## INA Service Info

# Quieter engine

## Changing from a rigid belt pulley to an over-running alternator pulley

Manufacturer: BMW

Image 1: Changing from a rigid belt pulley to an over-running alternator pulley

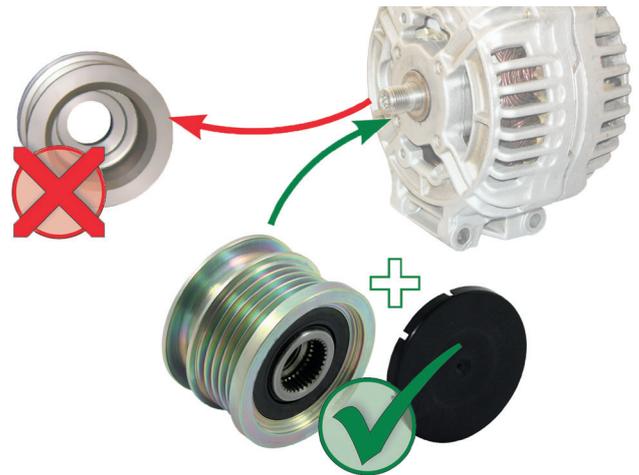
Vibrations and loud noises from the front end accessory drive may be produced in the vehicles listed above with a rigid alternator belt pulley. These vibrations and noises are caused by the rotational irregularities in the diesel engine, which are greater than those in a petrol engine.

Schaeffler Automotive Aftermarket recommends that the vehicles affected with a rigid alternator belt pulley be retrofitted with an over-running alternator pulley. Attention: It is essential that the enclosed installation instructions are observed!

The over-running alternator pulley disengages the front end accessory drive from the rotational irregularities of the engine, ensuring that the V-ribbed belt runs more smoothly and quietly. As a result, the engine is quieter, making your drive more comfortable.
